June 10, 2022

NWB File No. 2AM-DOH1335

Re: Type A Water Licence 2AM-DOH1335 Modification – Madrid East Naartok Portal

Figure 2: Waste Rock Storage Facility Expansion

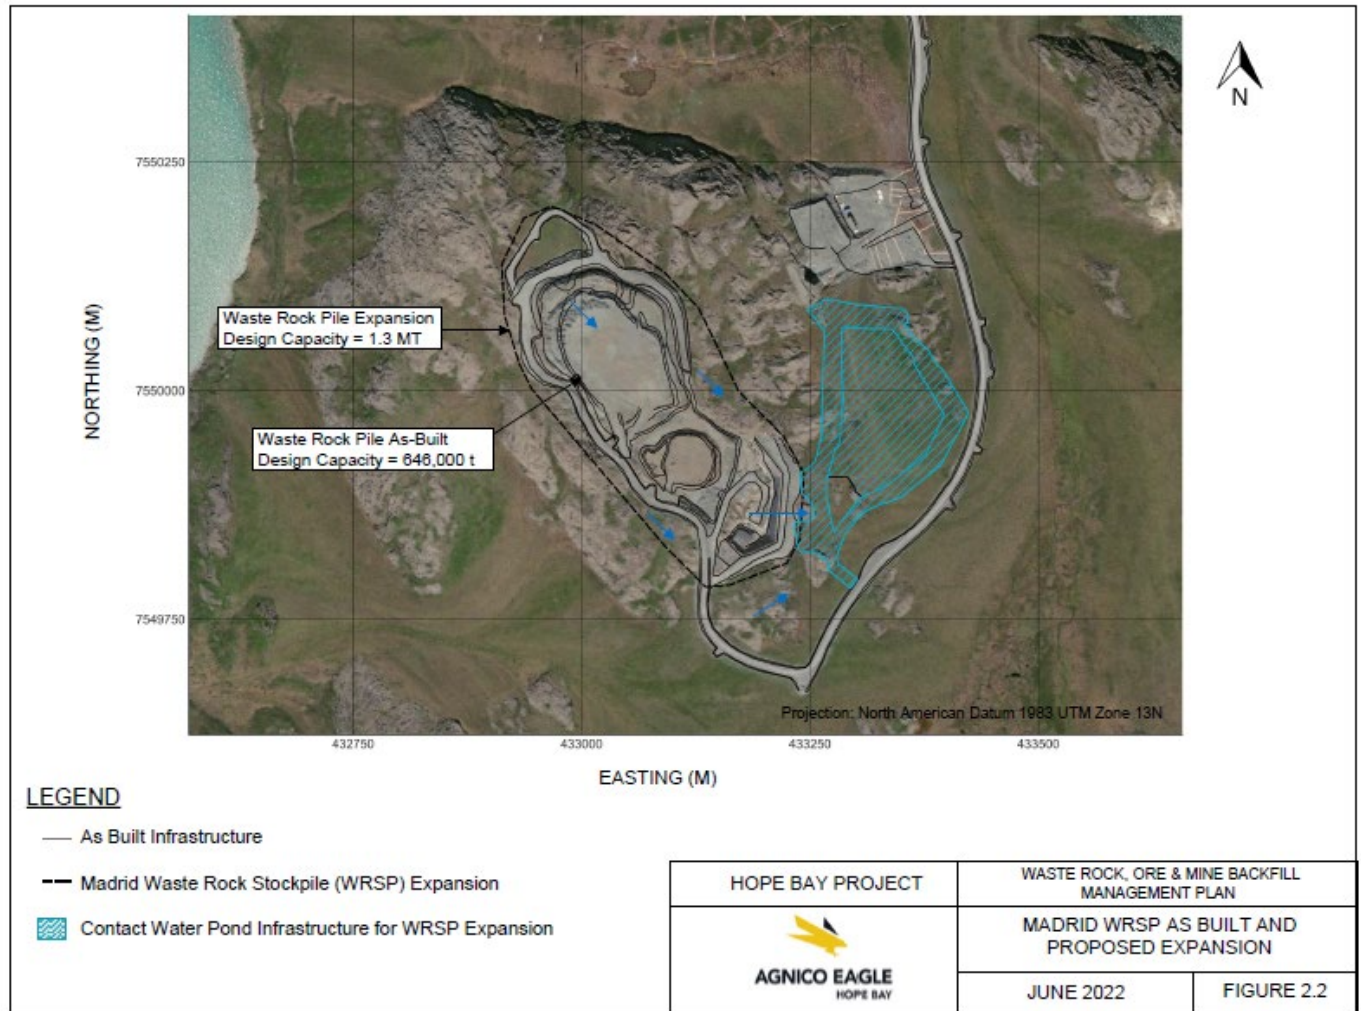
The existing waste rock pile at Madrid (i.e., yellow polygon in Figure 1) will continue to be used for waste rock storage and will need to be expanded (i.e., black dashed line in Figure 2) to accommodate increased volumes coming from the Naartok East Portal. Actual permitted waste rock storage is for 650k tonnes and the expansion would allow to store up to 1.3 M tonnes. The facility expansion will be needed 18 months after the development ramp has started. All waste rock will be backfilled underground at closure.

Figure 3: Proposed Naartok Portal Location

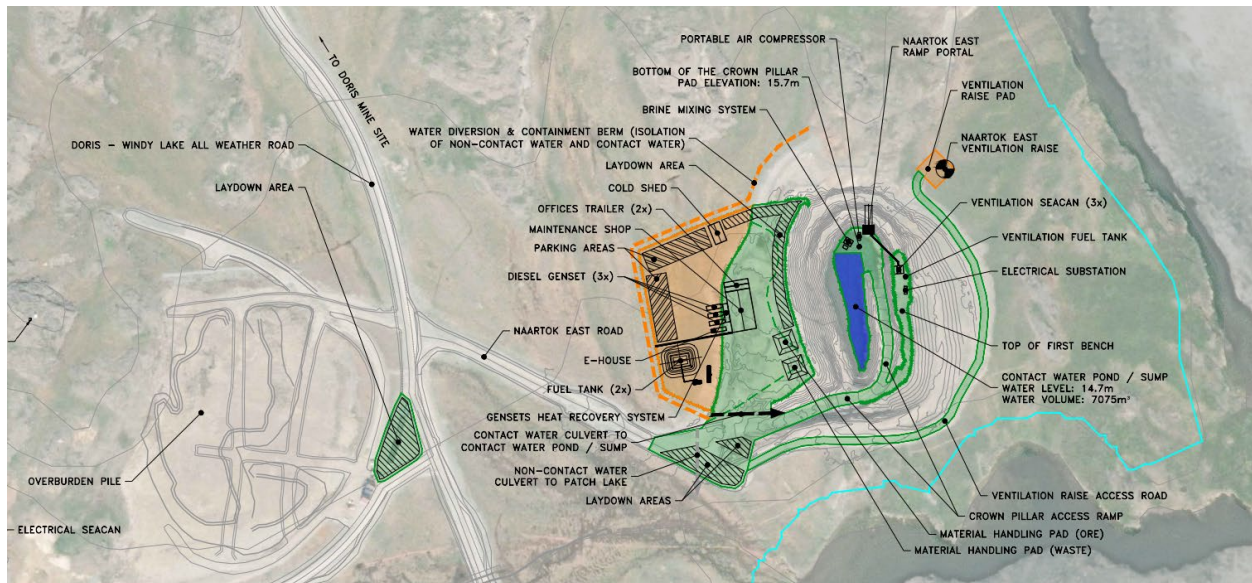
As presented in Figure 3, the new portal will be within the Project Development Area (i.e., blue line presented on figure) that was assessed as part of the Final Environmental Impact Statement. It will also mostly be within the existing Madrid Crown Pillar area that was mined in 2019-2020.
